ADDENDUM

Forestside Estates
Attmar & Palleschi Drive
Brampton, Ontario
Attn: **Vince Staffieri**

AM 08

PROJECT	**: Forestside**
PROJECT #	**: 1331.15**
DATE	**: Jan 18, 2021**

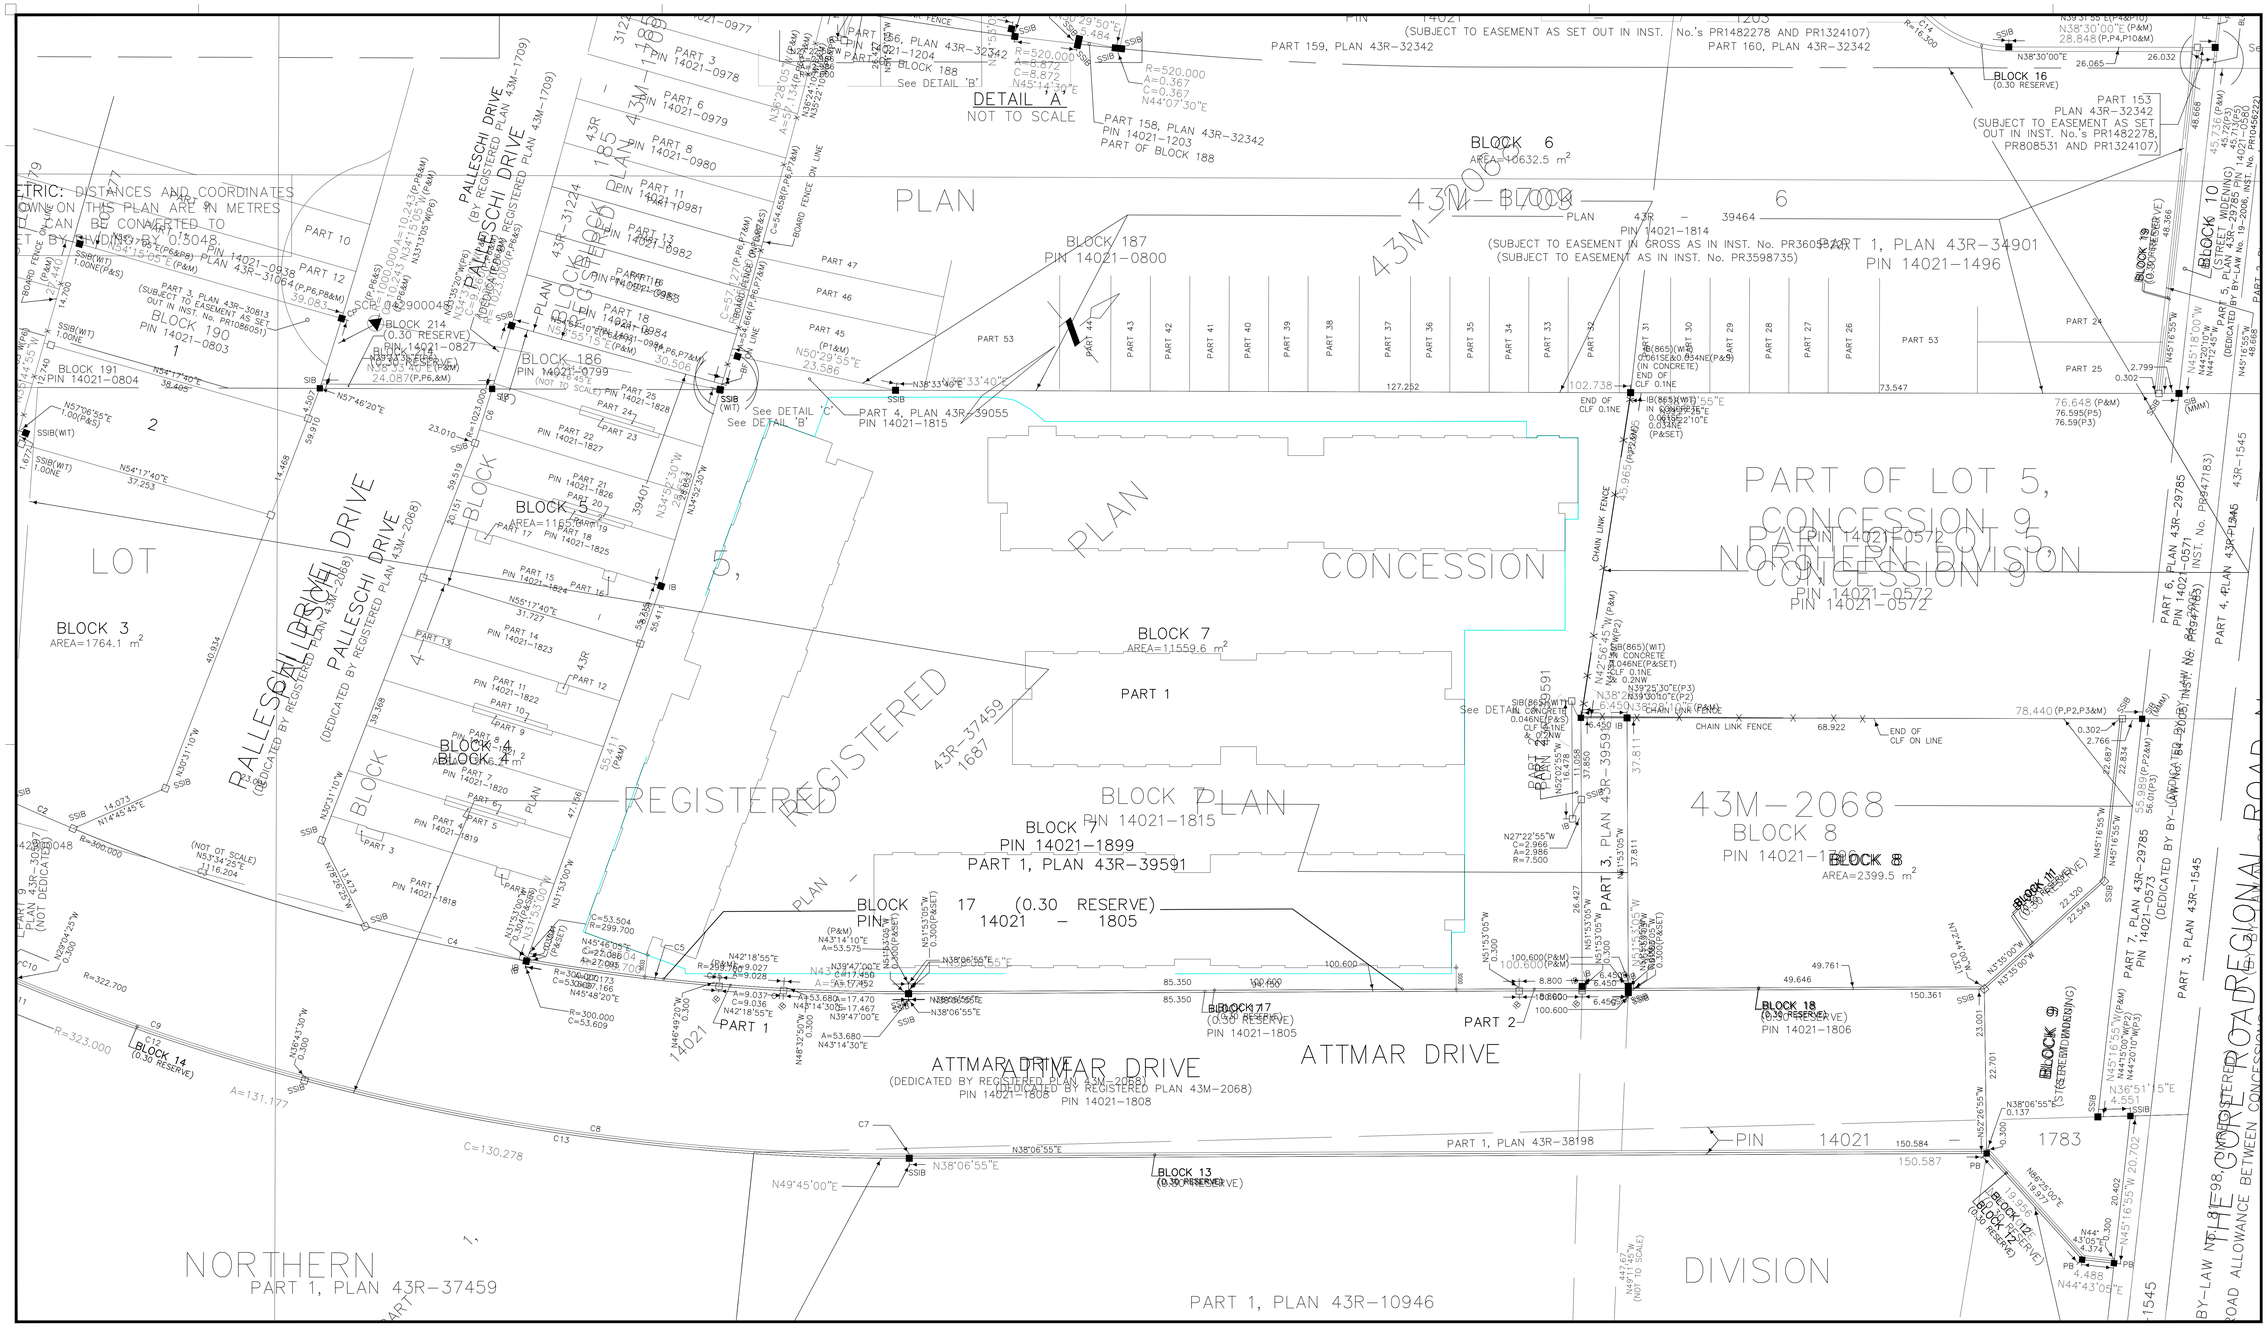
Reference:		Changes:
A101	Site Plan	• Move Blocks A and B north 286mm to comply with 0.3m easement and 3.0m minimum set back to property line as per clients request. • Move Block D up 390mm along angle north to comply with 0.3m easement and 3.0m minimum set back to property line as per clients request. • Revise extent of Underground as required by building move.
A201-A205	Fire Separation Plans	• Move Blocks A and B north 286mm to comply with 0.3m easement and 3.0m minimum set back to property line as per clients request. • Move Block D up 390mm along angle north to comply with 0.3m easement and 3.0m minimum set back to property line as per clients request. • Revise extent of Underground as required by building move.
A211	P1 Underground Plans	• Move Blocks A and B north 286mm to comply with 0.3m easement and 3.0m minimum set back to property line as per clients request. • Move Block D up 390mm along angle north to comply with 0.3m easement and 3.0m minimum set back to property line as per clients request. • Revise extent of Underground to include shifting of elevator walls, air locks walls and stair walls as required by building move.

Reason: **Move Blocks north to comply with 0.3m reserve and meet the 3.0m minimum setback to the property line as directed by client.**

GROUND FLOOR OVERALL PLAN

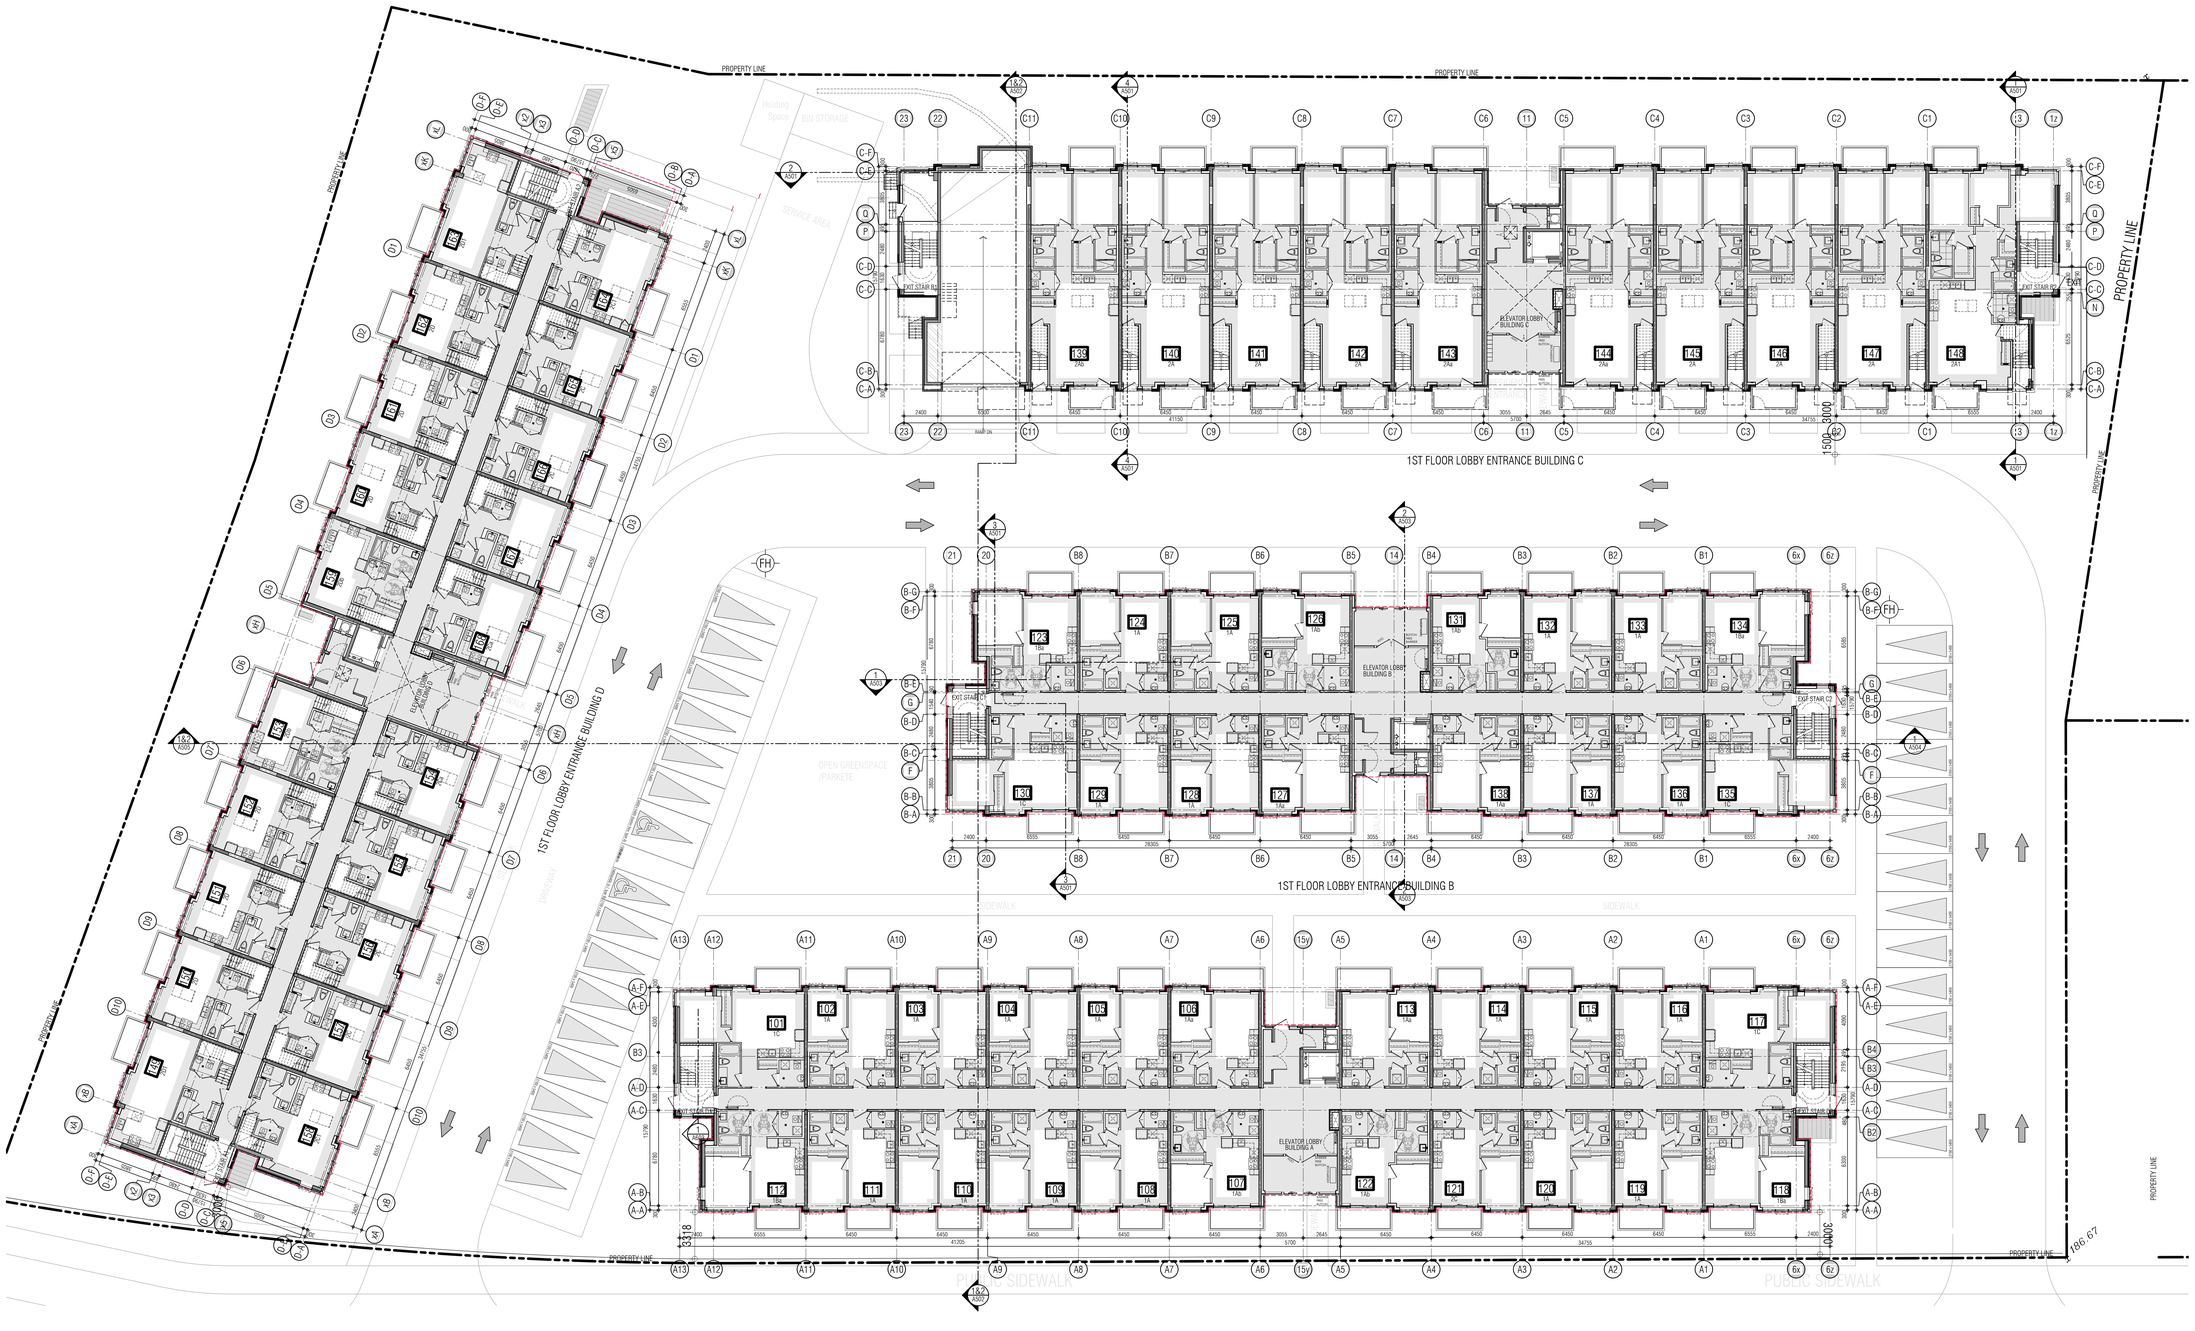
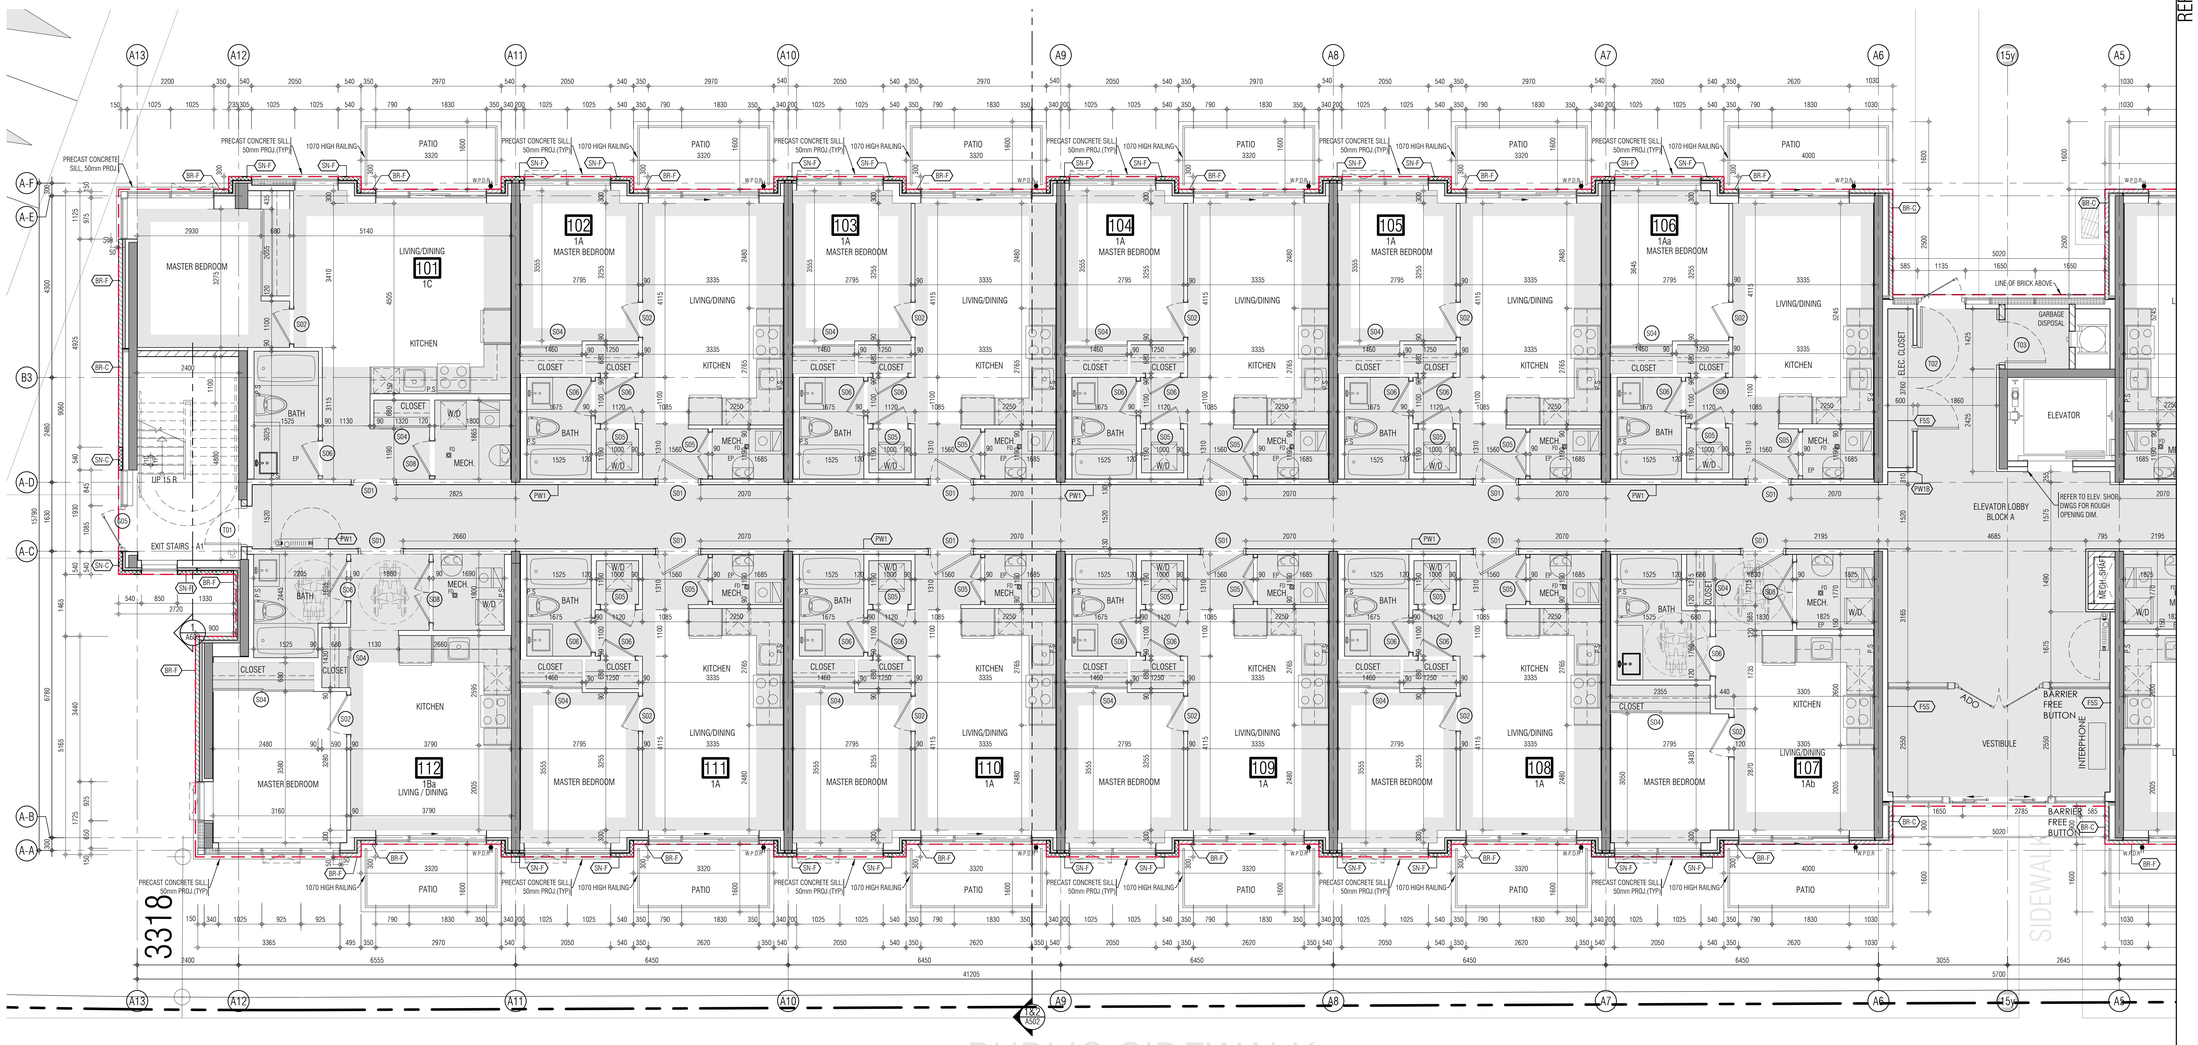
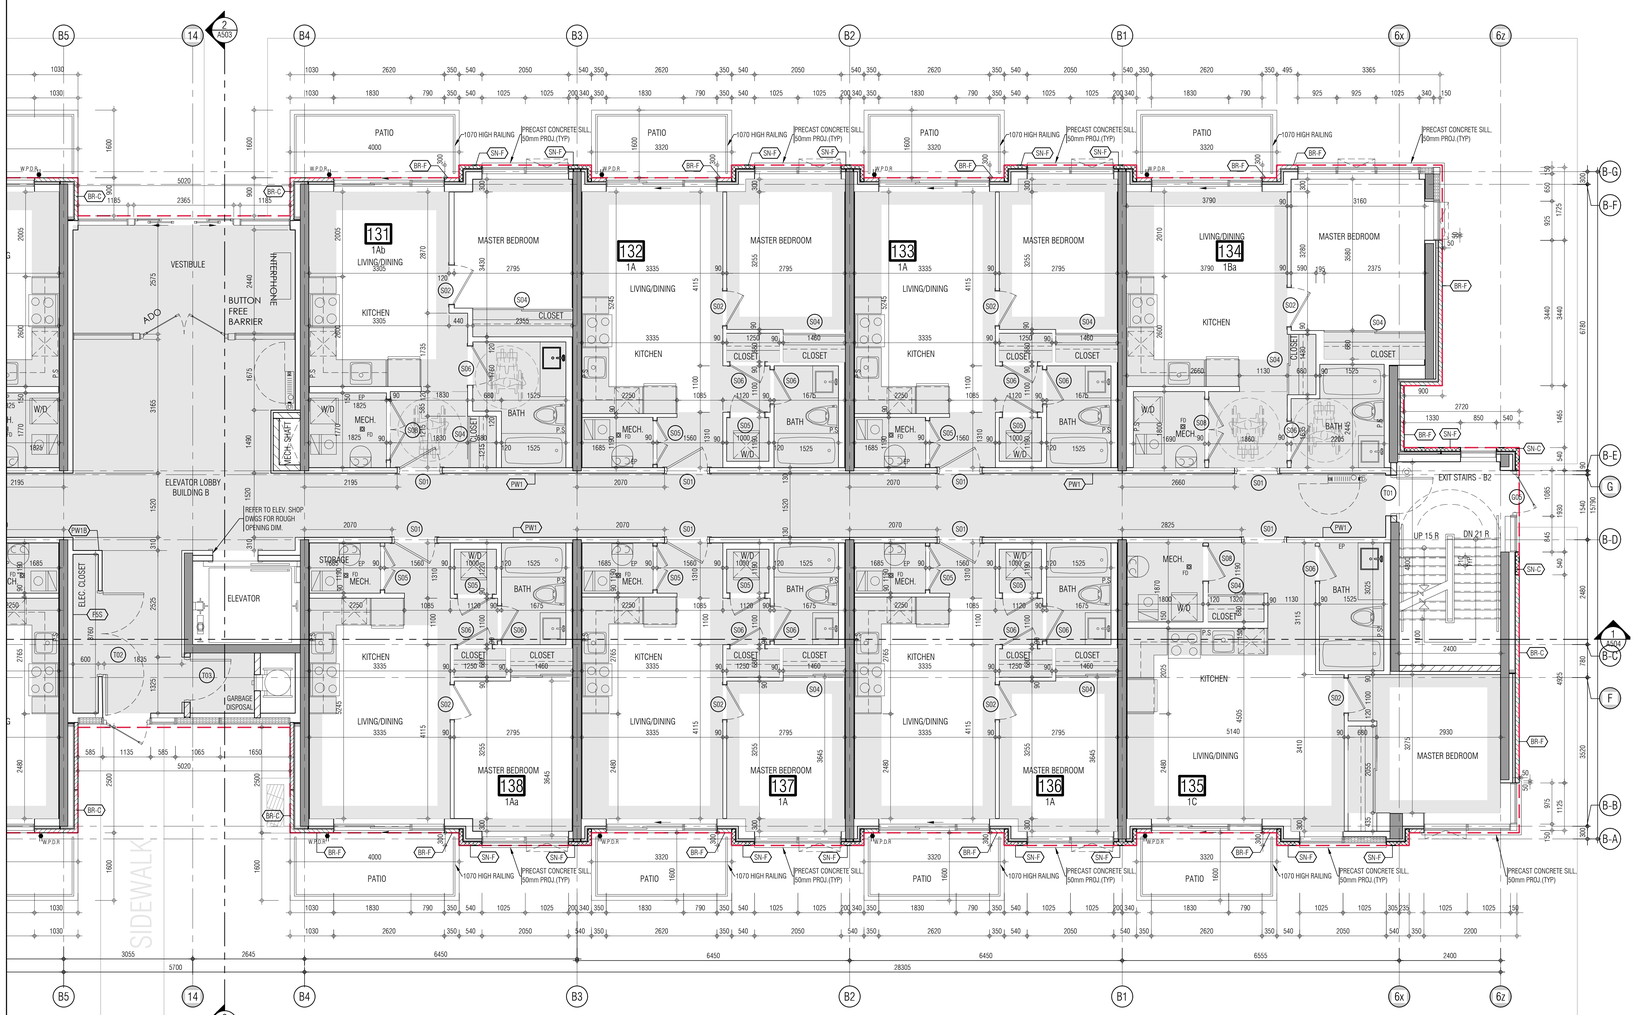
A301-A304	1st – 4th Floor Plans	• Move Blocks A and B north 286mm to comply with 0.3m easement and 3.0m minimum set back to property line as per clients request. • Move Block D up 390mm along angle north to comply with 0.3m easement and 3.0m minimum set back to property line as per clients request.
A701a-A701b	Stair Sections	• Revised dimensions on stair plans to match blocks that were moved.
